LEFT TURN LANE DETAILS @ SOUTHWEST ENTRANCE

IRIGATION, TELEPHONE & ELECTRICAL CONDUIT SLEEVE PLAN						
VILLAGE ON THE PARKWAY						
VILLAGE PARKWAY VENTURE						
Albert H. Holt Associates, Inc. - Engineers						
CITY OF ADDISON, TEXAS						
DESIGN	DRAWN	DATE	SCALE	NOTES	FILE	No.
A.H.H.	A.H.H.	April 79	1"=20'	6183

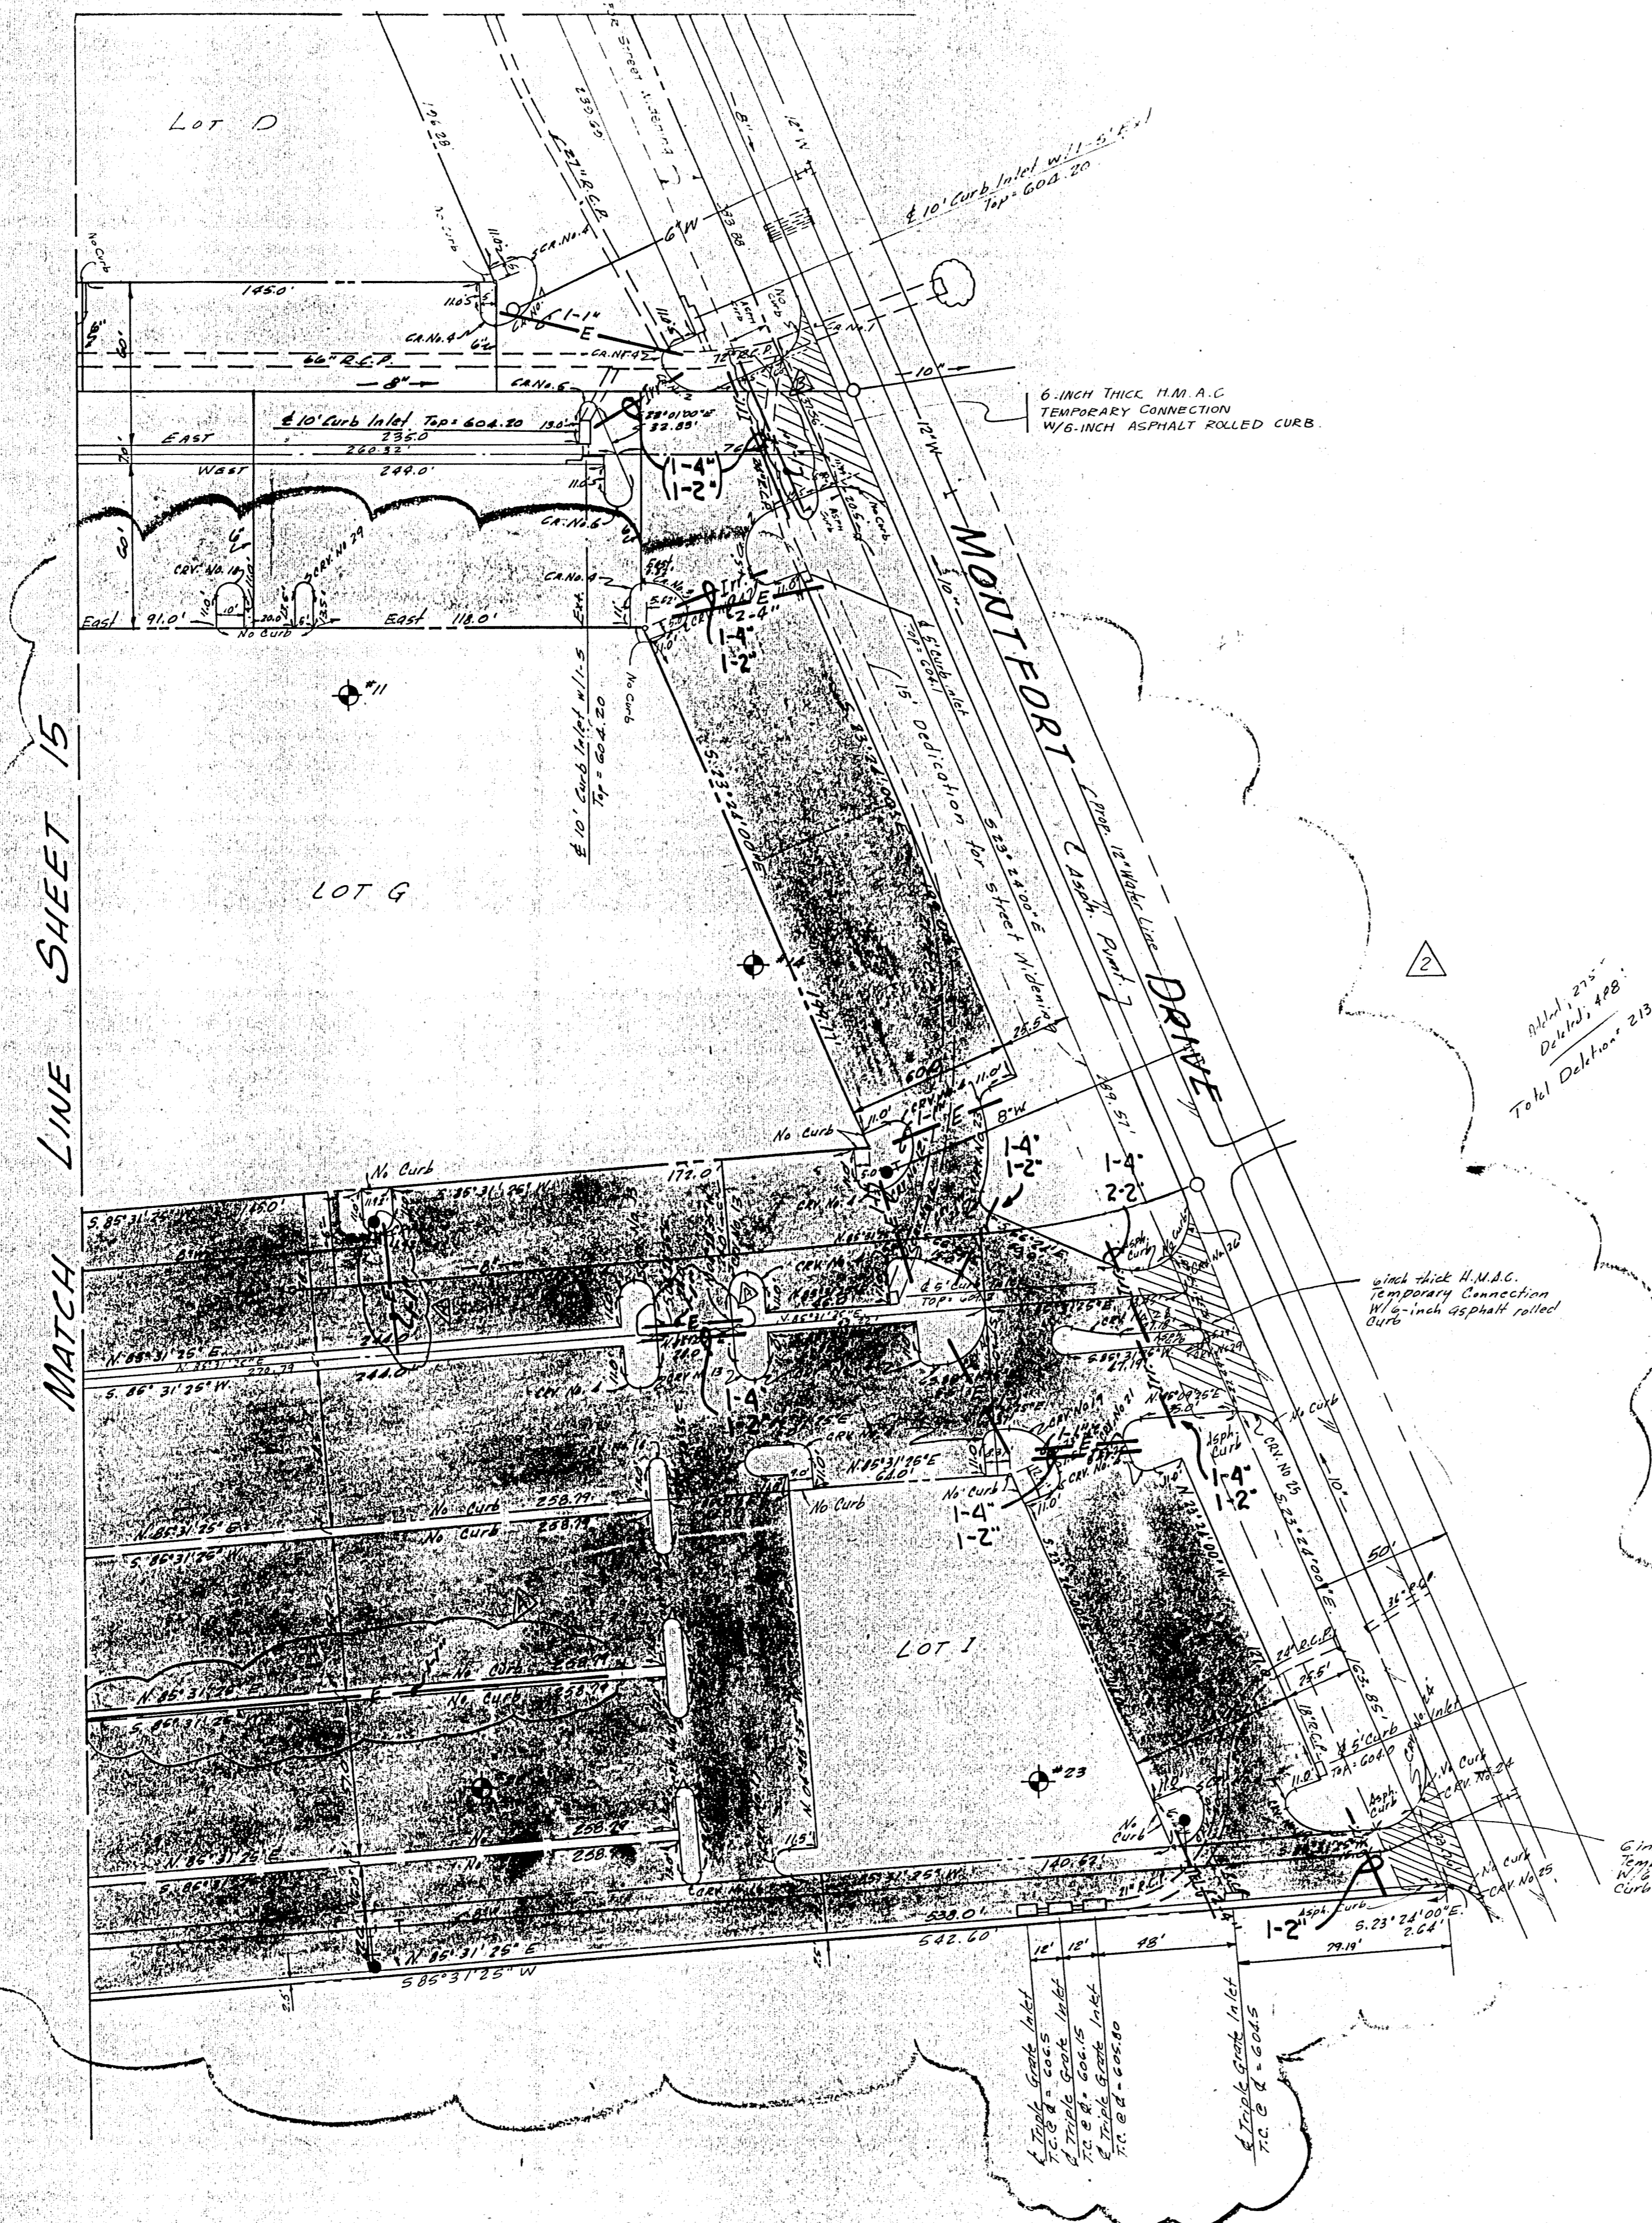
Change Order #14; 8-2-79 Added 1" Electrical Conduits  
Change Order #15; Added 1" Elect Conduit North Entrance @ Montfort

2/28/79 Added Horizontal Layout & Paving plan for second installation.  
7/26/78 Added TURN LANE CURVE DATA
